USNRC APPLICATION
SUA-1341 License Amendment
Ludeman Project
Converse County, WY

June 2013

Path: C:\WY_Projects\8201-2013-102_Infrastructure\Project_MXD\Lueman_Water_Balance_Production_Restoration.mxd

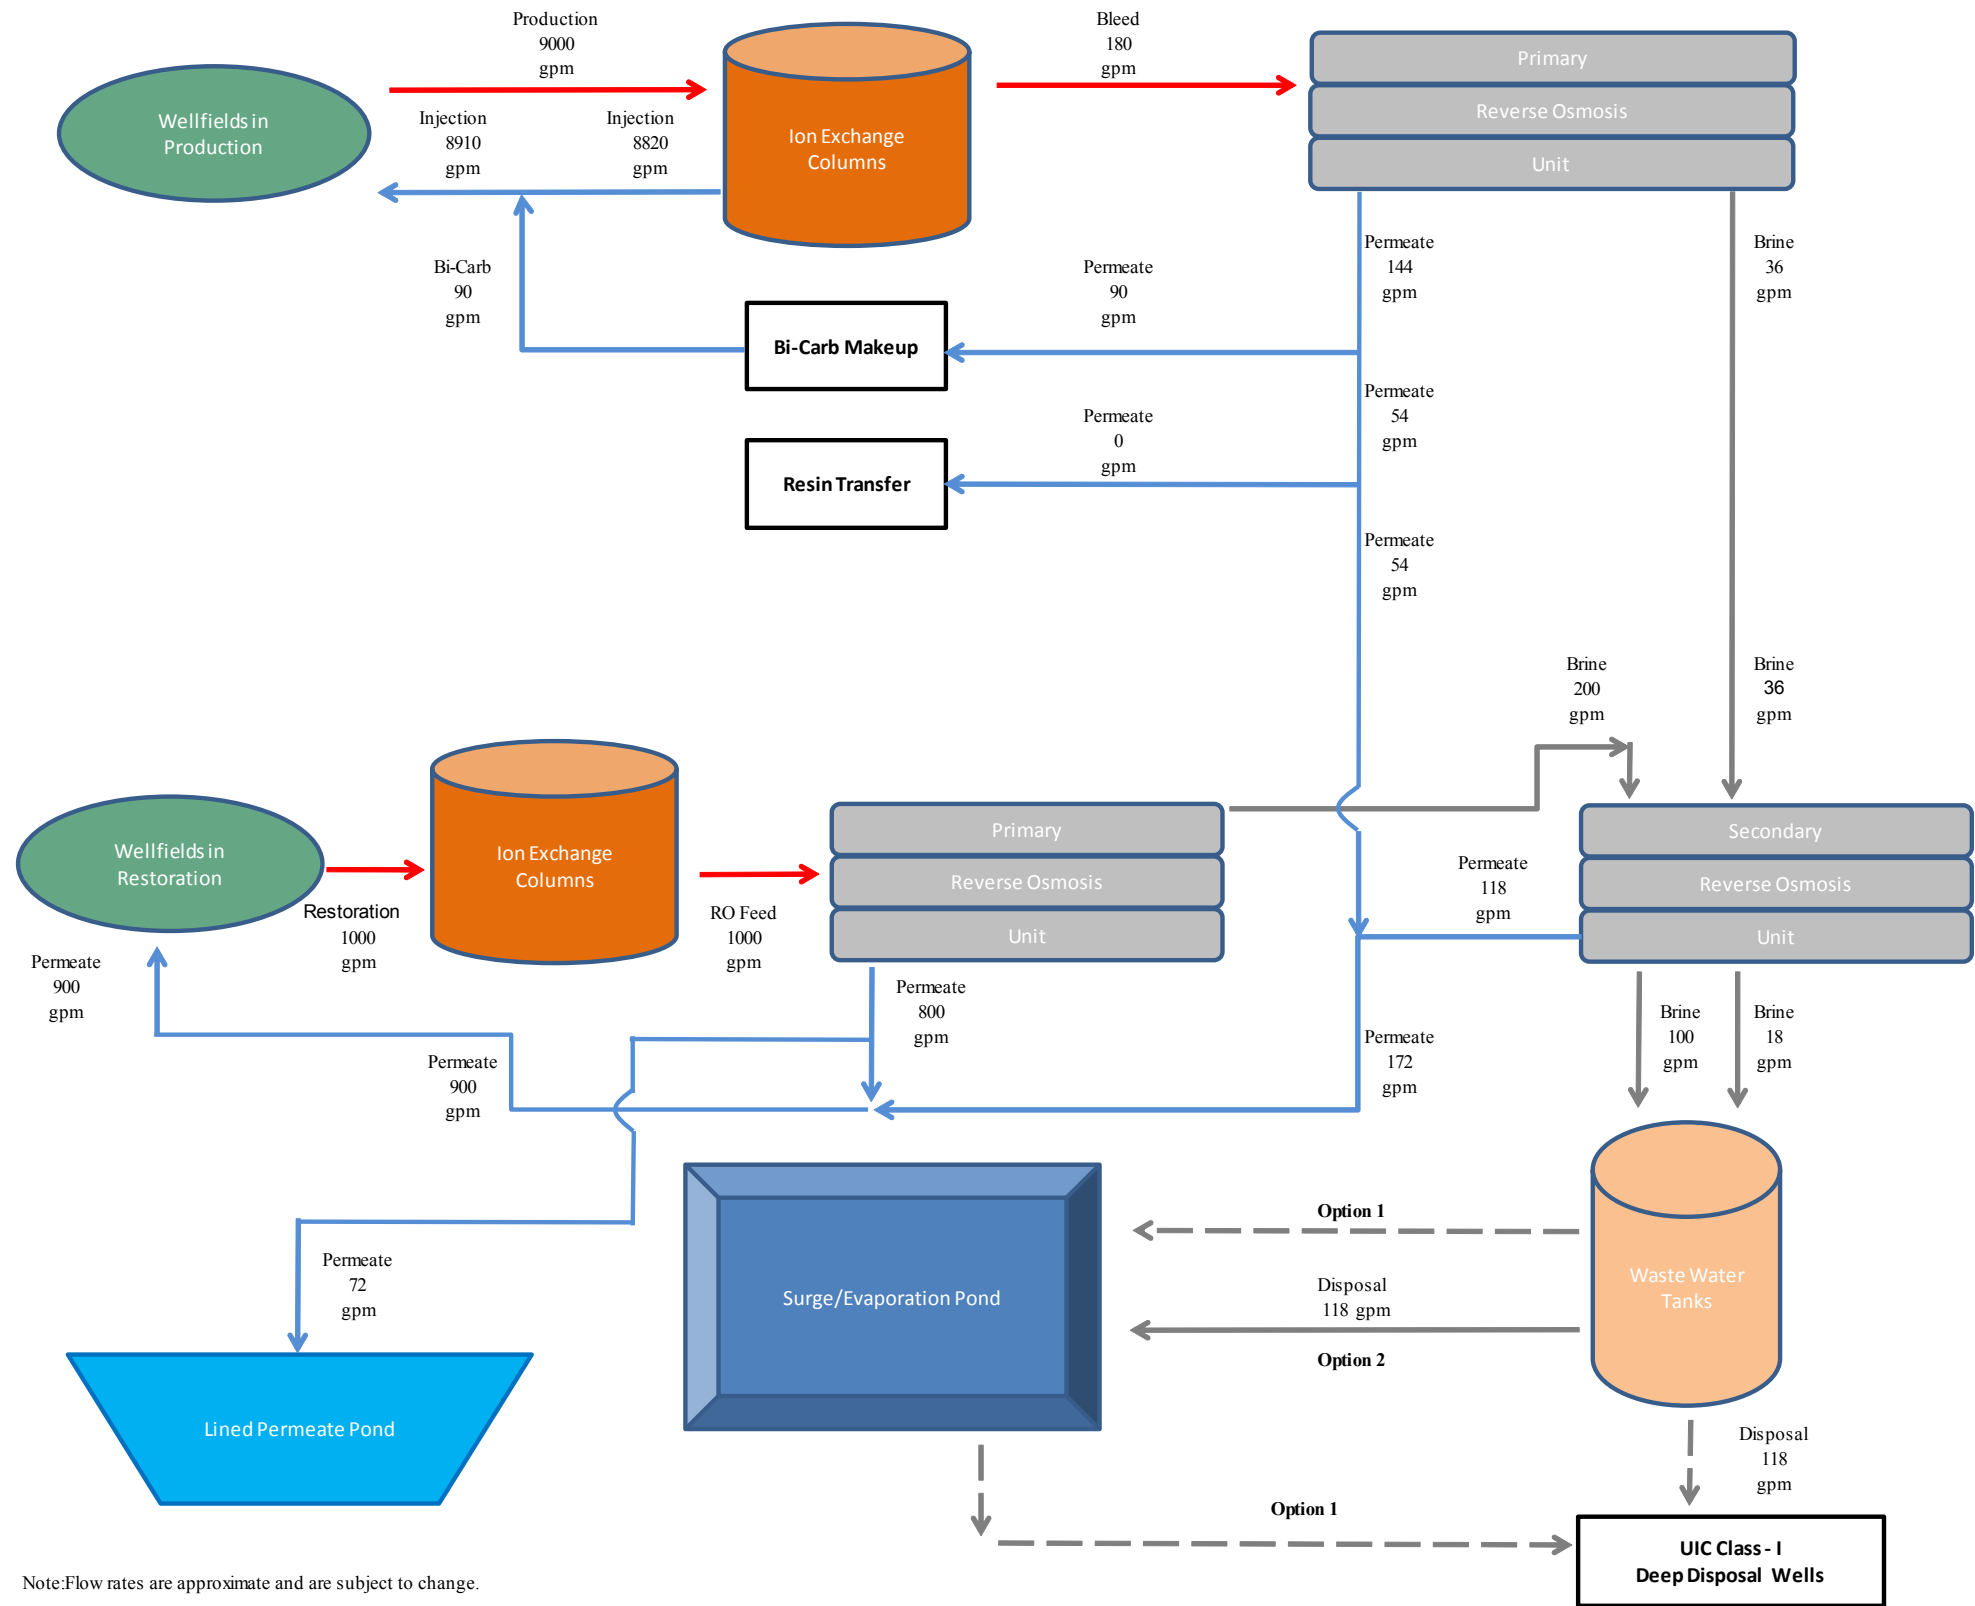
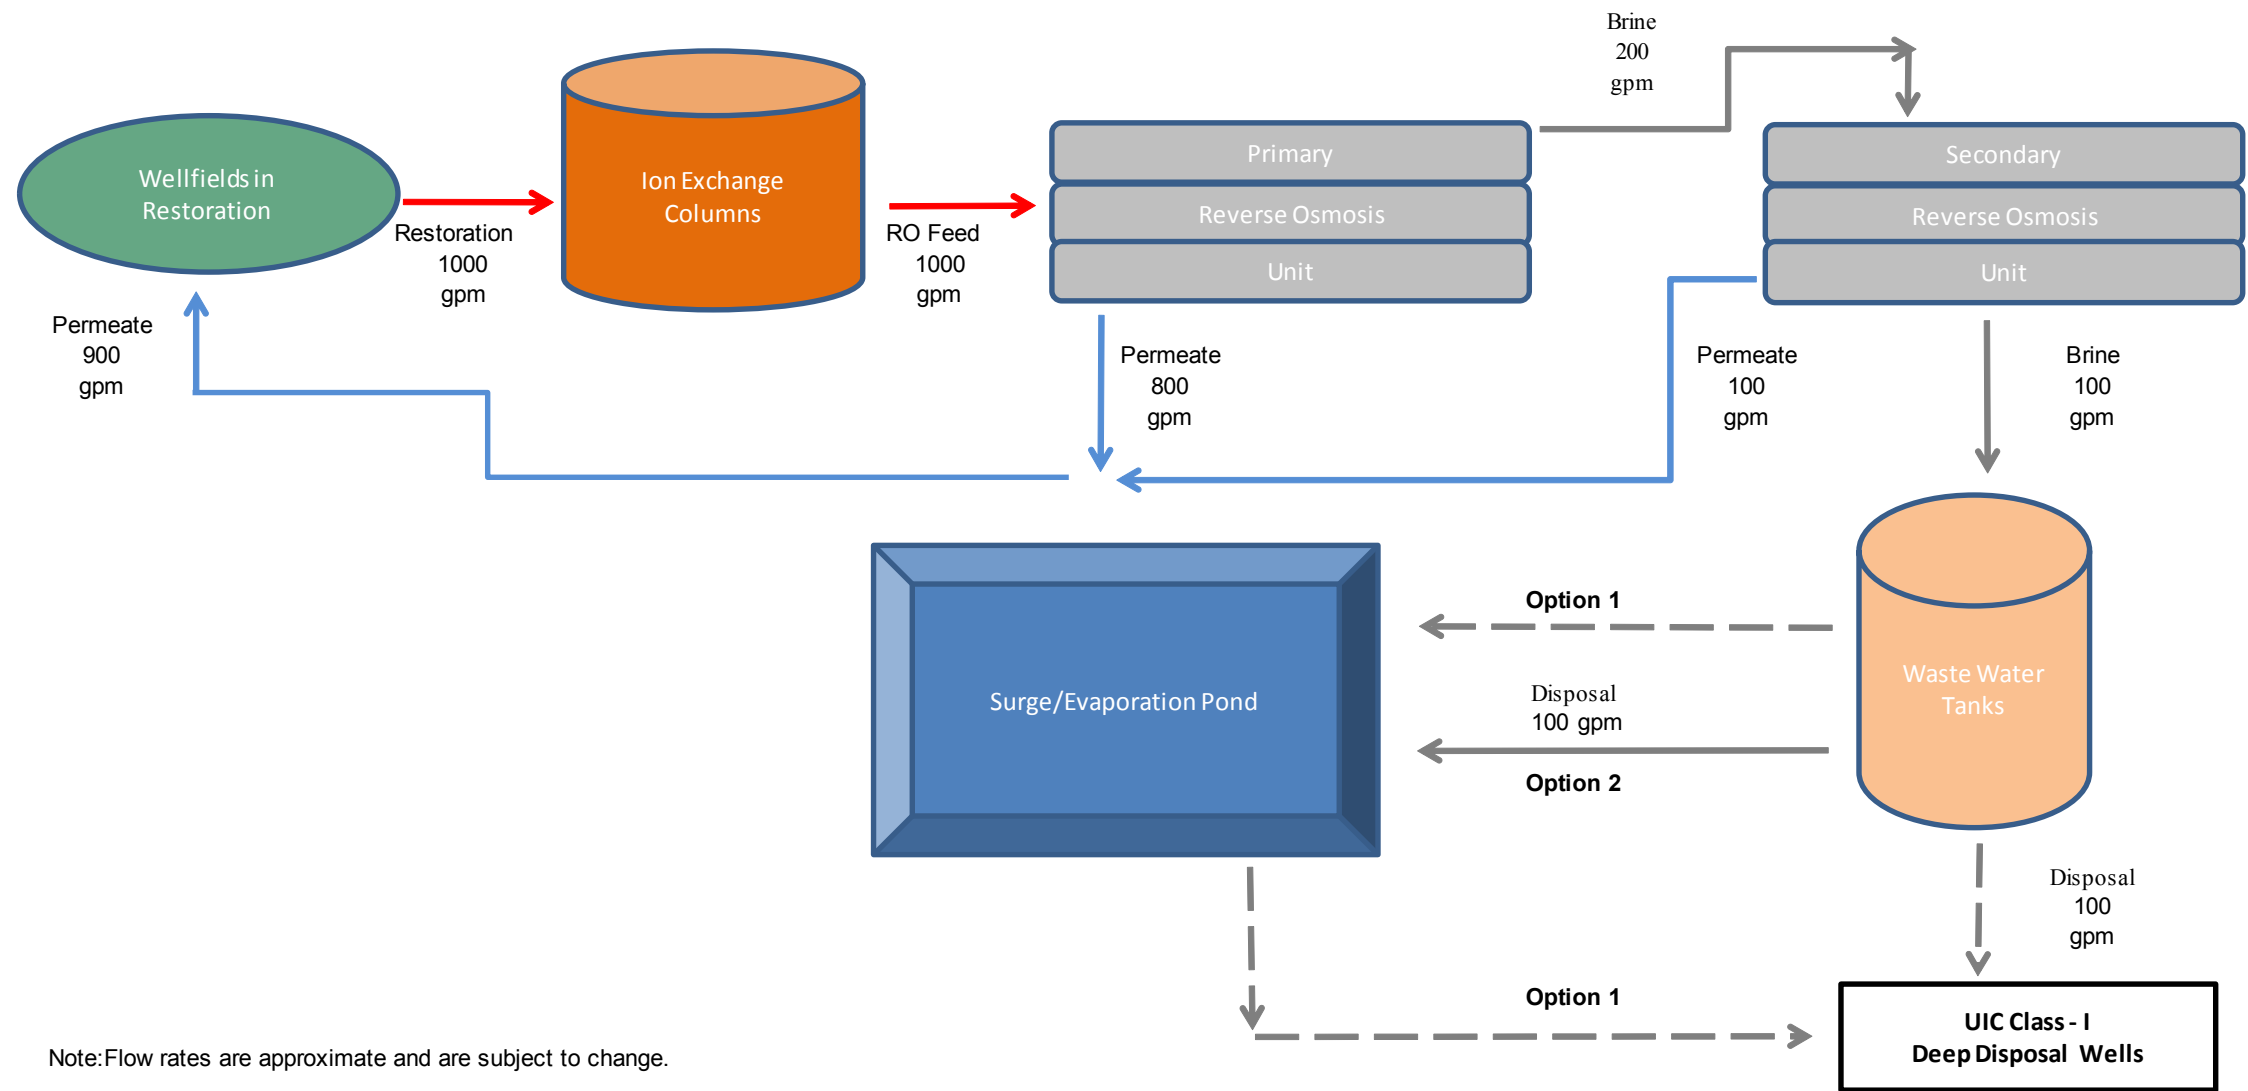
TR Section 3.1.6 presents a generic water balance for the production phase and restoration phase for all Ludeman satellites in Figures 3-6 and 3-7, respectively. The water balance was not specific to each satellite. The estimated waste disposal rate required at each satellite will be 60-160 gpm. The staff notes the field rates for existing DDWs in the Tecla Teapot Parkman formation (not projected permitted rates) at currently licensed ISR DDWs in the Powder River Basin are approximately 30 gpm on average. The TR indicates that only two DDWs will be installed for each satellite; therefore, each DDW would need to achieve rates of 30-80 gpm during operations. Staff cannot provide reasonable assurance that Uranium One has sufficient waste disposal capacity without a separate water balance at each proposed satellite for each phase of operation which includes realistic estimates of DDW rates based on field values from similarly situated DDW wells in the Powder River Basin.

Uranium One should: (a) provide a separate waste water balance specific to each proposed satellite and phase of operation including production, production/restoration restoration for each year of operation in table format; and (b) demonstrate that only two DDW will be sufficient to handle the expected waste disposal rates of 60-160 gpm at each satellite. If, Uranium One determines two DDWs will not be sufficient, address how sufficient disposal capacity will be achieved.

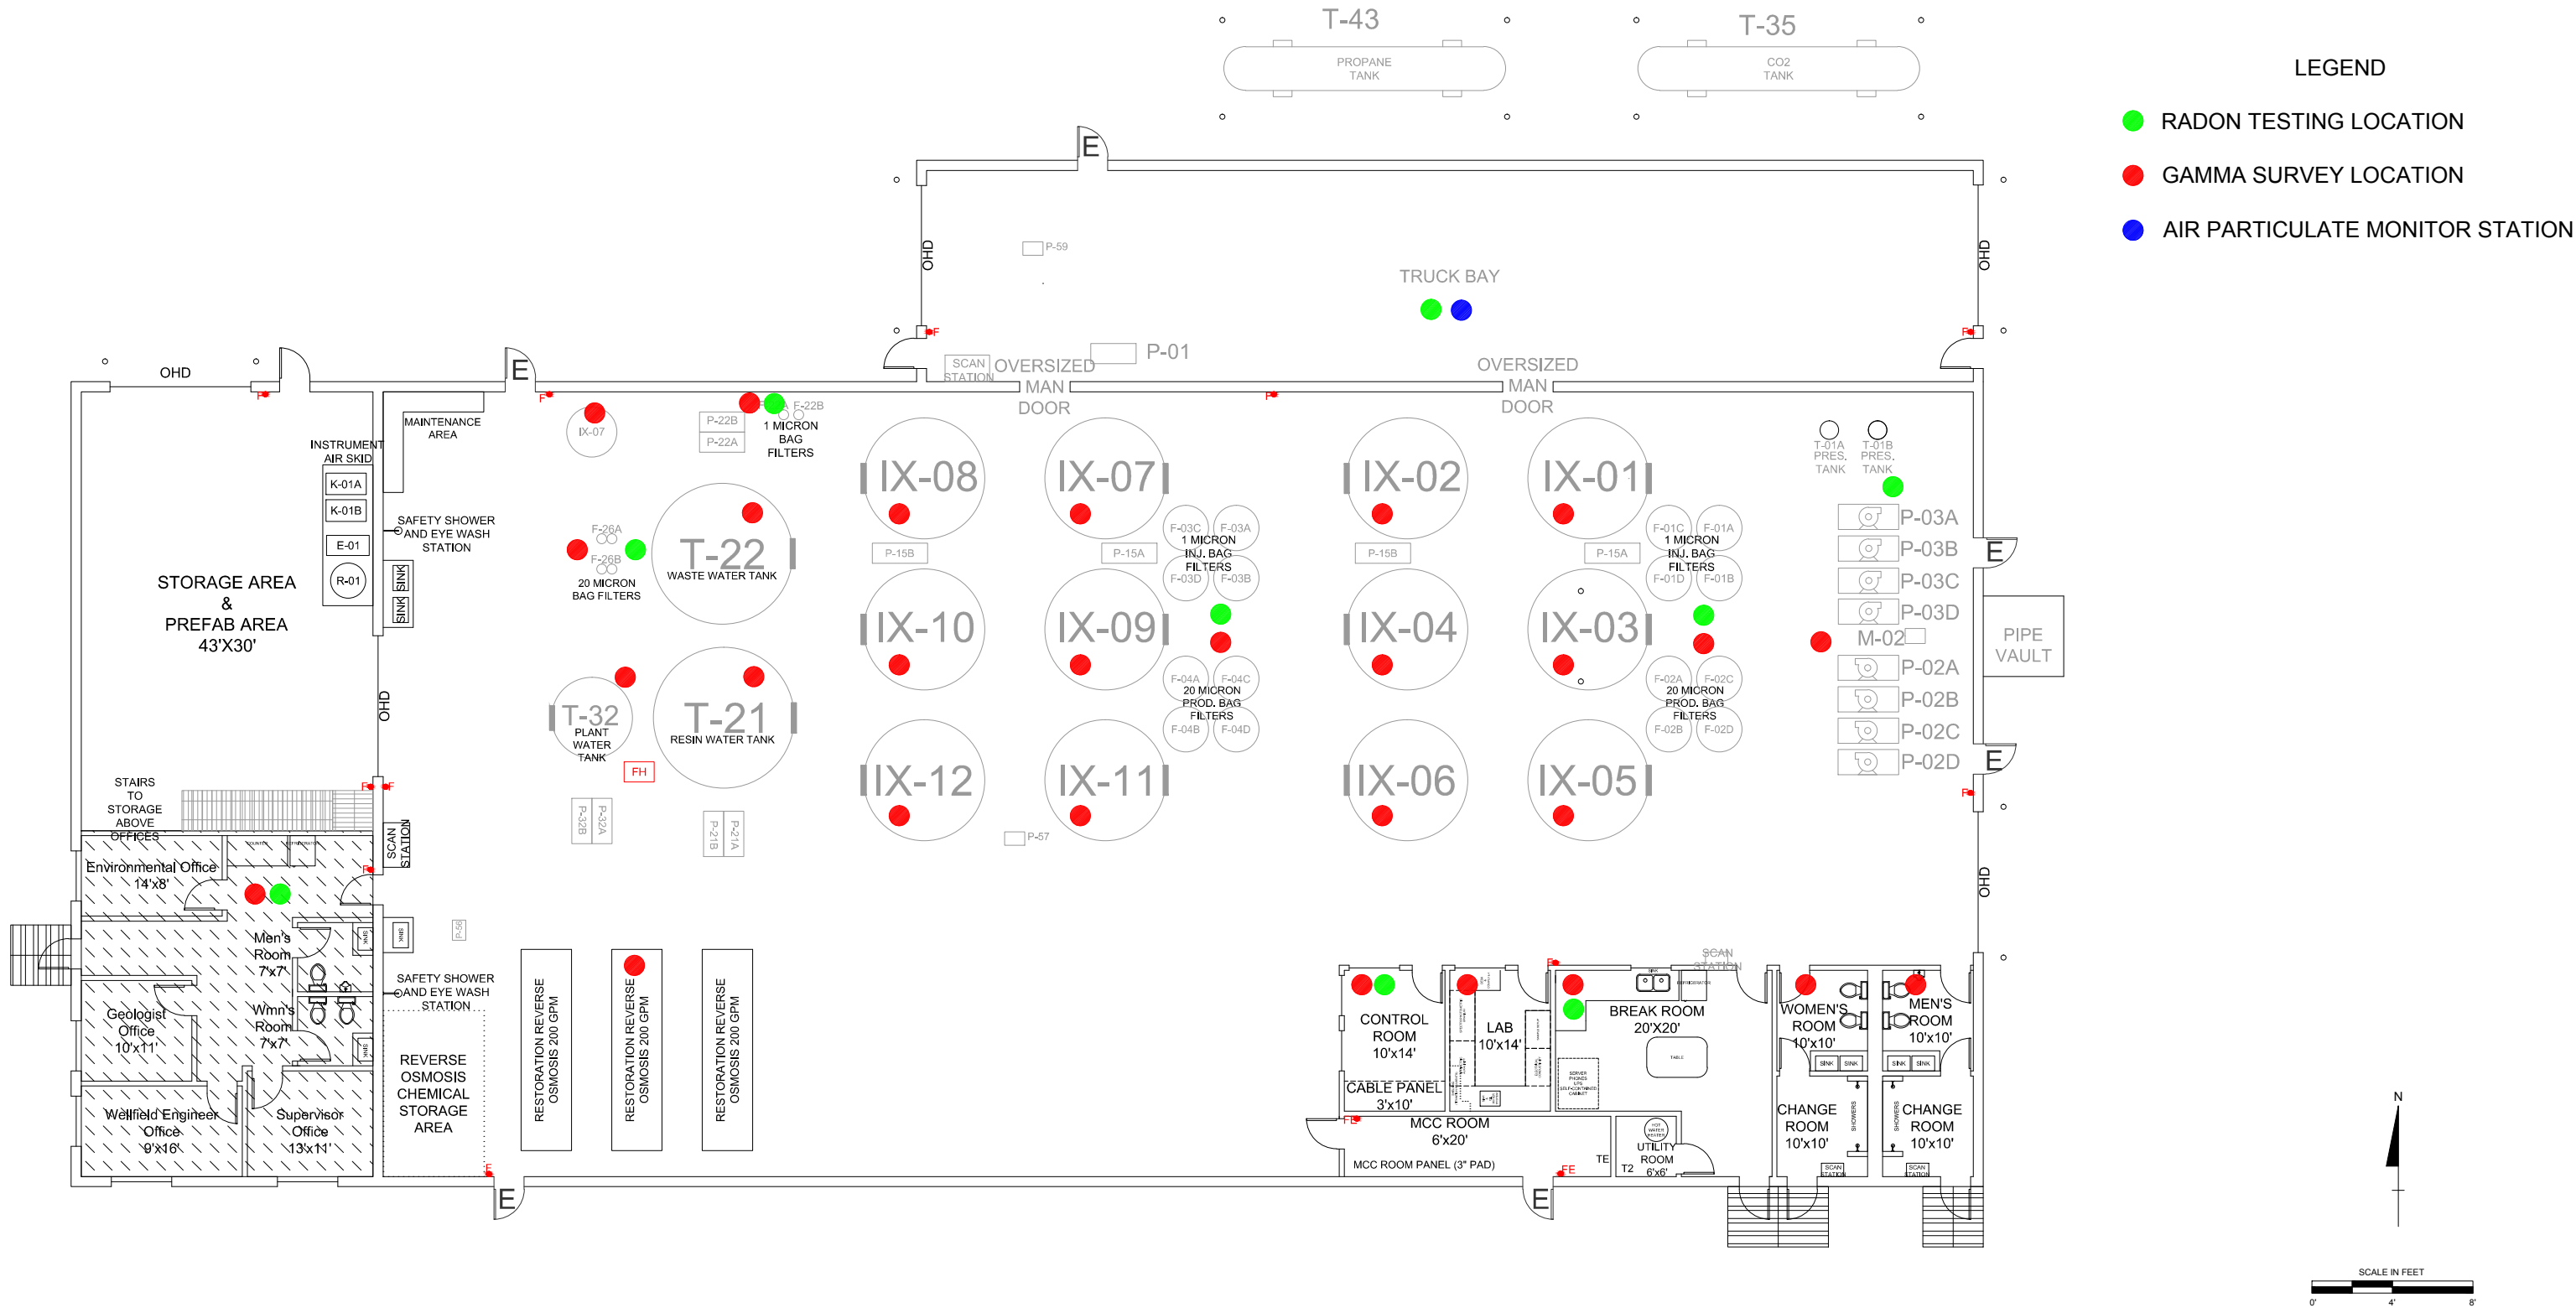
Acceptance criterion (1) of SRP Section 5.7.2.3 states that the applicant should provide one or more drawings that depict the facility layout and the location of samplers for airborne radiation and that locations of samplers should be consistent with Regulatory Guide 8.30. Figure 5.2 of the TR does not identify the location of air particulate samplers. Figure 5.2 only shows where Radon and gamma dose rates will be surveyed. Further, TR Section 5.7.3.1 states that routine airborne uranium particulate sampling is not proposed for the Ludeman satellite facilities because no drying or packaging activities will be conducted. Uranium One does not address the potential for spills which can be a source of airborne particulates. Although, Regulatory Guide 8.30 does not address sampling for spills, the regulatory guide states that the purpose for airborne uranium particulate sampling is to determine whether exposures to radioactive materials are being maintained ALARA as stated in 10 CFR 20.1101 and 20.1702.

Uranium One believes NRC meant to reference criterion (1) of SRP Section 5.7.3.1 rather than 5.7.2.3. As stated in Uranium One's response to RAI 86, airborne particulate sampling locations will be added to the satellite resin transfer bay areas and will be consistent with existing sampling locations at the Christensen Ranch Satellite facility which operates under SUA-1341.

Figure 5.2 of the TR was modified and is shown below:
